Re: Comments to CARB Proposed 2018 Improvements to Vehicle Fill Pipe Specifications

This comment letter is based on conversations held within the SAE Refueling Task Force committee to help further improve the CARB Fill Pipe and Opening Specification. Our proposal and comments are as follows:

Proposed SAE J1140 Filler Pipe Face Clearance
(Yellow Area is not to be encroached for proper boot sealing)

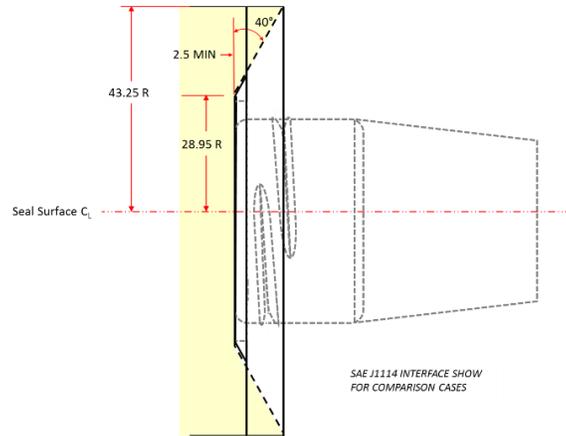
Figure A Recommended Changes:

- Figure A needs clarity on the definition of the zone.
 - With the current figure if tapered zone starts at, for example 52.0mm seal surface, the 40° clearance zone would end before reaching the 86mm outer range, and is not defined.

- TG proposes replacing Figure A with the proposed SAE J1140 Filler Pipe Face Clearance.
 - This establishes a fixed zone for the nozzle bellows referenced in CARB TP-206.
 - Fixing the zone allows for the clearance and relevance to Spherical, conical, and planar nozzle boots.

Figure B: Set-up of Testing Equipment

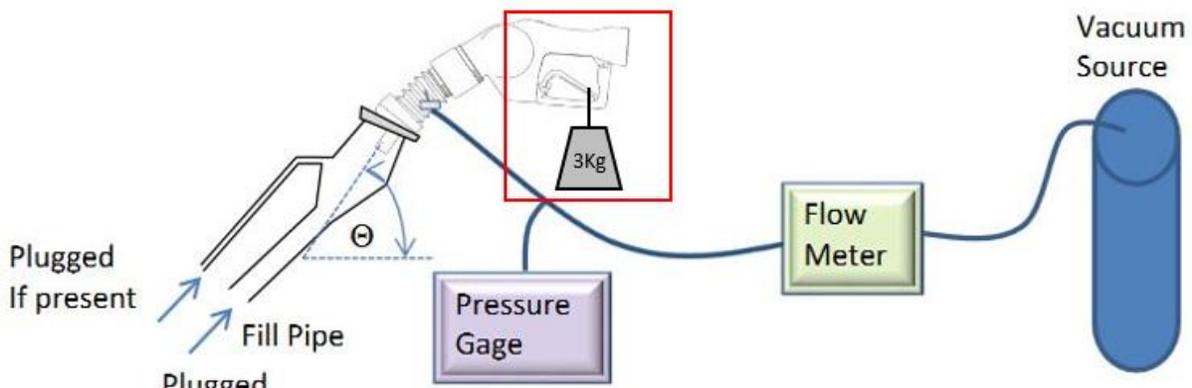
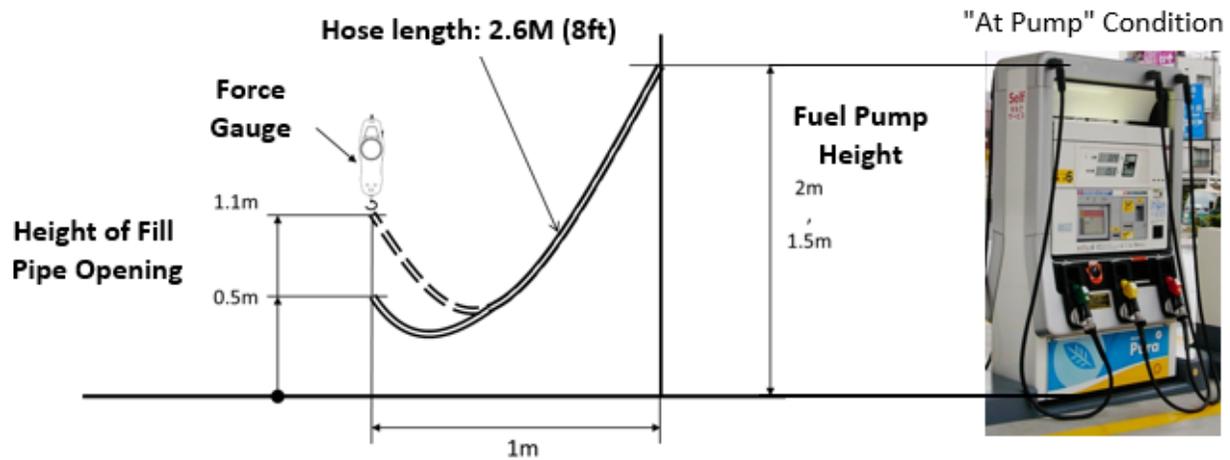
Figure B Recommended Changes:

The purpose for the proposed changes above in Section VIII and Figure B is to help standardize the leak rate bench test and eliminate any testing variation across OEMs and Suppliers. The clarification of using the Healy 900 makes sure that all parties conducting this test use the same nozzle and also helps provide similar results to previous CARB testing done that also used the Healy 900 nozzle. Additionally, it is also specified to use the most recent Healy 900 EOR nozzle to make sure that all parties are using the most up to date nozzle.

- F. Latch an ~~assist type~~ Healy 900 EOR vapor recovery nozzle into the fill pipe using a natural motion as you would when filling up your own car at a gas station.
- G. ~~Hose should form a "U" shape, and be within 6-12 inches from the ground at its lowest point~~
Hang a 3Kg (30N) weight from inside the nozzle handle shown in Figure B.

Lastly, we would like to propose the elimination of using a hose to simulate the “at pump” condition and use a specified weight instead. The purpose of this is to eliminate any variation in testing between different parties and also make it more clear and concise on how to simulate this “at pump” weight. Our proposal comes from a study that we did that shows the difference in weight on the end of the nozzle depending on hose length and how the hose was setup. Please see Hose Study below in Table 1.
